## MEMO

**To:** Kristopher Byrd, Well Construction Manager  
**From:** Tommy Laird, Well Construction Program Coordinator  
**Subject:** Review of Water Right Application G-18342  
**Date:** May 29, 2024

# Groundwater Application Review Summary Form

Application # G- 18342

Water-Level Trends in Nearby Wells

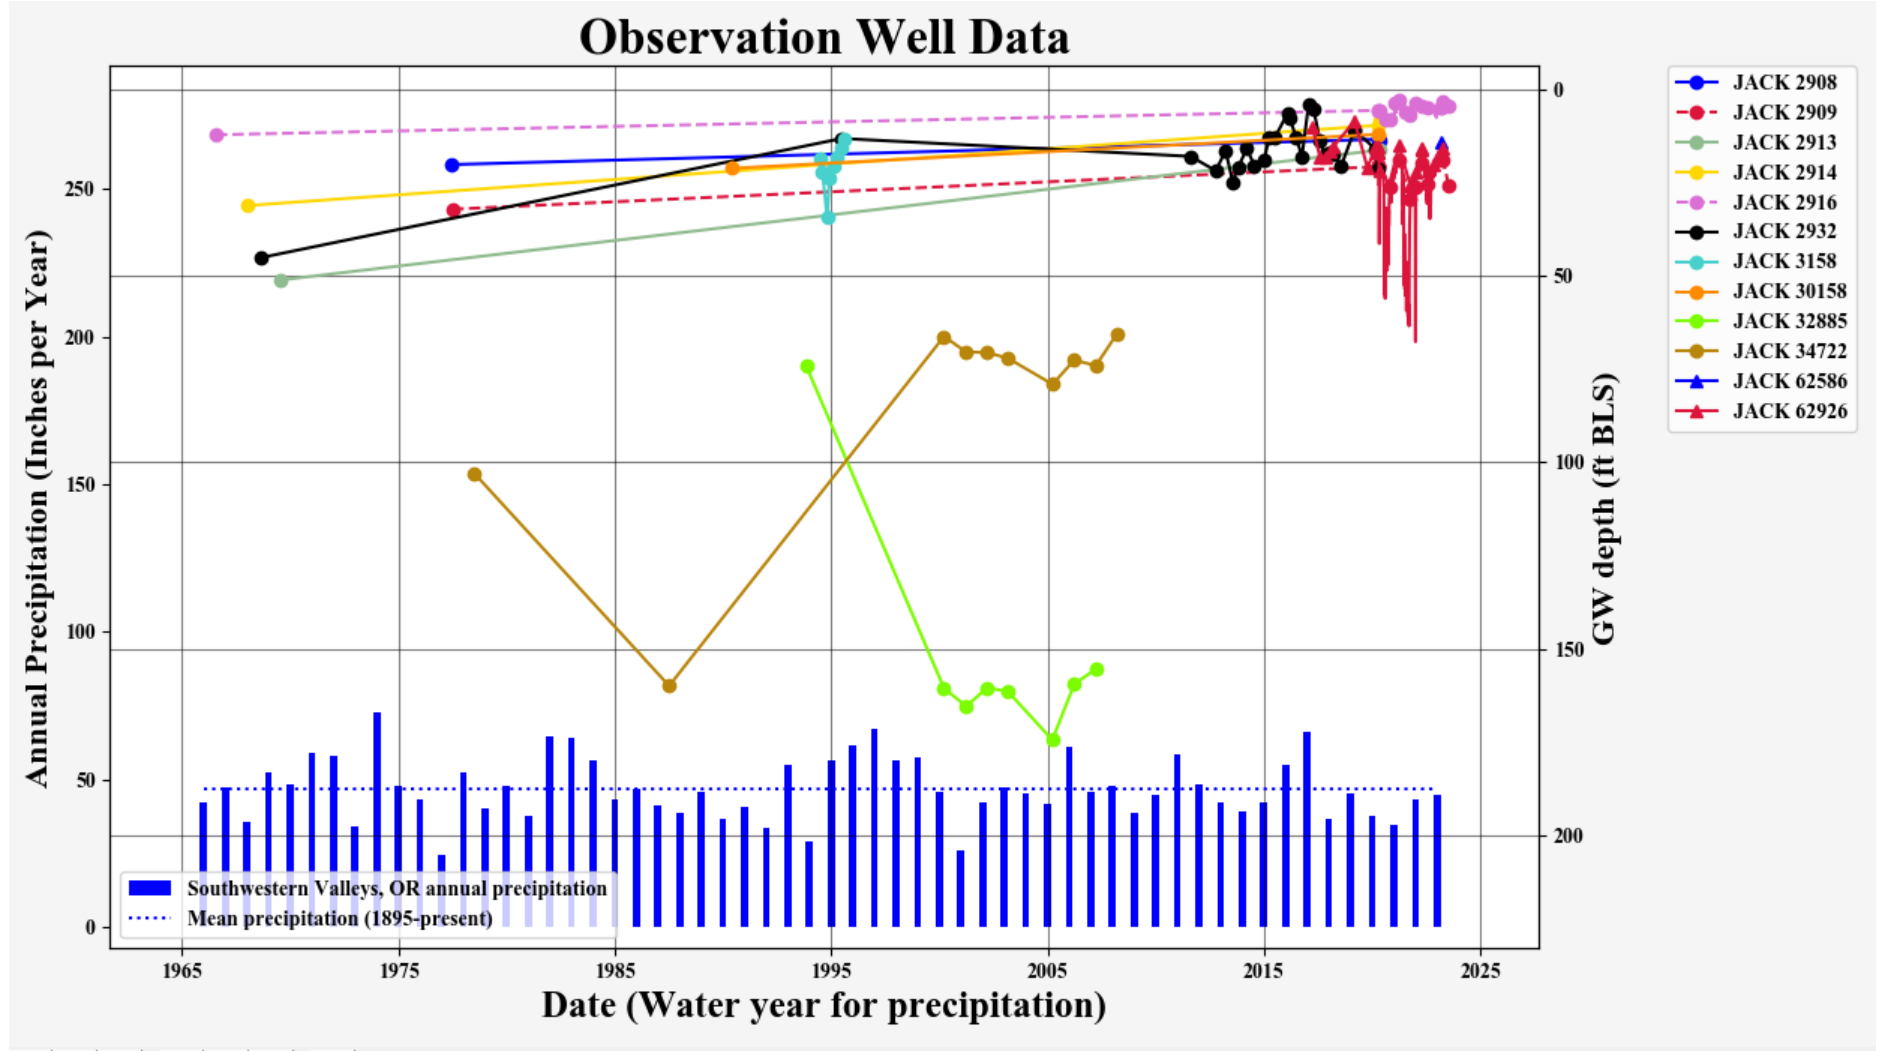
- B3. **Groundwater availability remarks:** The applicant requests the use of 0.167 cfs (75 gpm) from a single proposed well for 30 acres of nursery use. The applicant's well would access an aquifer hosted in the secondary porosity (fractures and joints) within early Western Cascades volcanics (Wiley and Smith, 1993) (Hladky, 1992). Water levels in adjacent observation wells indicate moderate seasonal fluctuations (10-15 feet) with larger drawdown (>50 feet) resulting from well-to-well interference. Water level records do not indicate any year-on-year declines at this time so the resource does not appear to be over-appropriated as per current understanding of pertinent rule and statute. However, the target aquifer has relatively low storage and is constrained by the extent and interconnection of water bearing fractures, making the target aquifer prone to persistent seasonal declines and well-to-well interference.

OFR 2021-05 (Kemper, 2021, available at [https://www.oregon.gov/owrd/wrdreports/OFR\\_2021\\_05\\_report.pdf](https://www.oregon.gov/owrd/wrdreports/OFR_2021_05_report.pdf)) documents the results of a pumping test conducted by OWRD staff in April 2020, in which well XP-7 (JACK 30158) was pumped for 8 hours at 142 GPM causing 14.6 feet of drawdown at XP-5 (JACK 2909) and 7.6 feet of drawdown at Harrington-2 (JACK 62926 under permit G-16926). This report shows that the target aquifer consists of a heterogenous fracture network that functions as a single aquifer but has interconnected fractures that propagate pressure quickly between wells that share that fracture system. To assess injury from this application, Theis distance drawdown modeling with aquifer parameters from OFR 2021-05 estimates that pumping from the proposed well location at the requested rate (0.1671 cfs) would cause 25-85 feet of drawdown at JACK 62926 within 1-5 days. This would trigger decline conditions for JACK 62926 and for this application and require regulation of the proposed well. In addition, groundwater in the target aquifer flows primarily through fractures, so full penetration of senior groundwater users is not necessarily required for a finding of injury (OAR 690-008-0001(8). **Considering the hydrogeologic context and high magnitude of interference, the requested use is determined to injure JACK 62926 and is not within the capacity of the resource.**
